IS 6873 (Part 1) : 2010
CISPR 12 : 2007

AMENDMENT NO. 1

Annex G

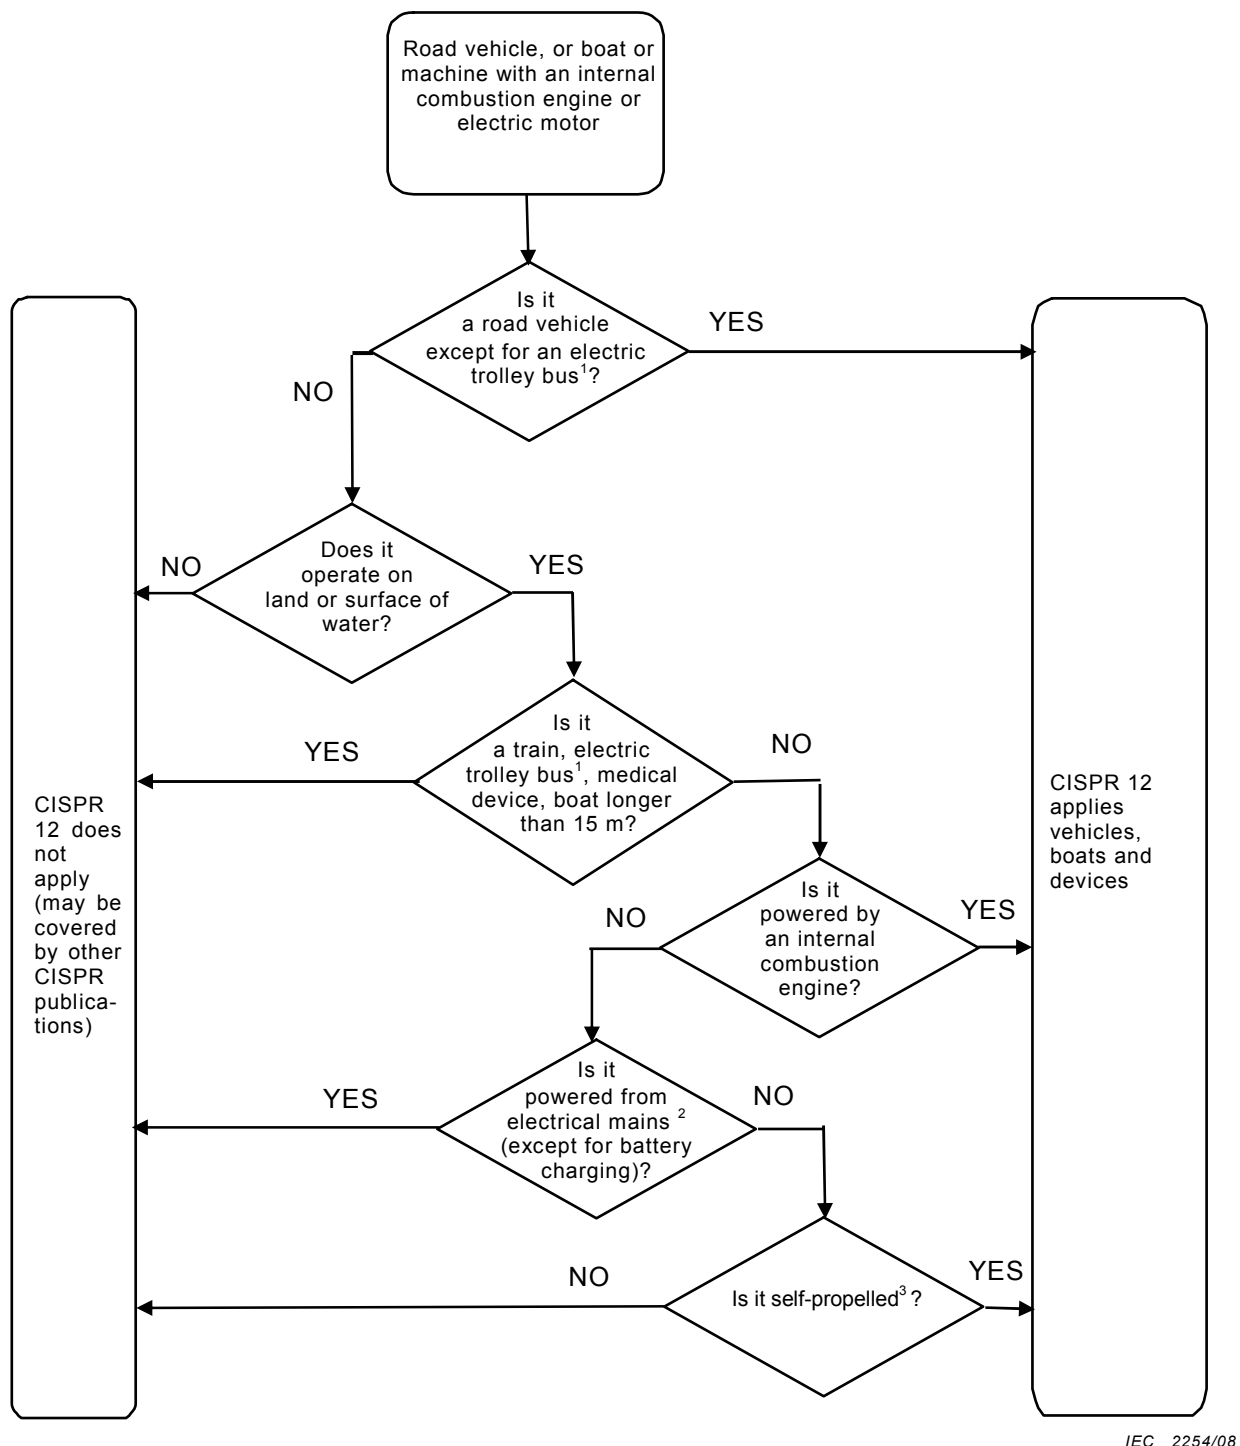
Replace the existing chart and its footnote by the following new figure and footnotes:

¹ In the case of a dual-mode trolley bus (e.g. propelled by power from either a.c./d.c. mains or an internal combustion engine), the a.c./d.c. mains portion of the vehicle propulsion system shall be excluded from this standard.

² Connection to the electrical mains is the work of another CISPR subcommittee.

³ Automatic battery powered cleaners are the work of another CISPR subcommittee.
